In Reply Refer To: HSSD/B-190

Name of system: F-Shape Concrete Traffic Barrier with Quick-Bolt Connection

Type of system: Portable concrete barrier system

Test Level: MASH-08 Test Level 3

Figure 5.7 Summary of results for *NCHRP Report 350* test 3-11 on Bexar Concrete Works F-shape CTB with Quick-Bolt connection

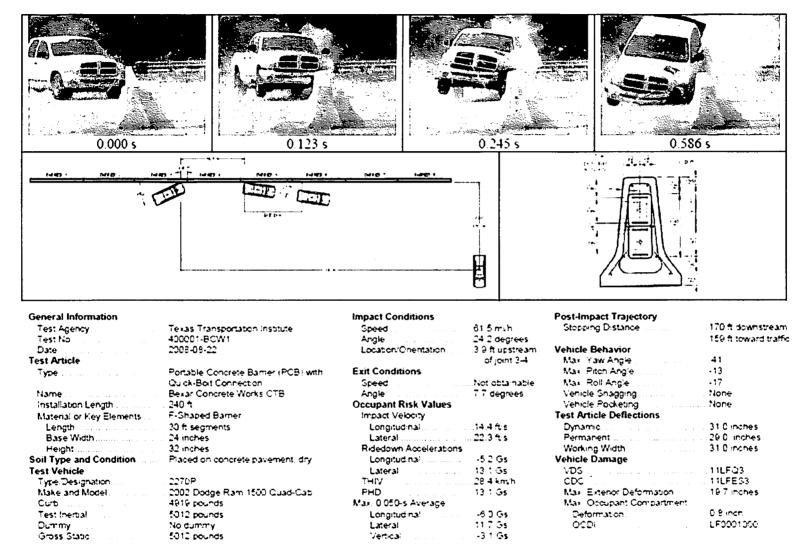
The Test Data Summary Sheet for test 4000001-BCW1 is enclosed for reference and shows the maximum occupant impact velocity was 22.3 feet per second (40 fps is allowed) and the maximum ridedown acceleration was 13.1 G's (20 G's is allowed.) Both of these maximum values were the lateral components. The maximum dynamic deflection was 31.0 inches. The maximum roll angle was 17 degrees and the vehicle exited the barrier within the "exit box" limits.

The MASH-08 Test 4000001-BCW1 met the appropriate evaluation criteria, therefore, the Bexar Concrete Traffic Barrier described above and detailed in the enclosed drawings is acceptable for use on the NHS under the range of conditions tested, when such use is acceptable to a highway agency.
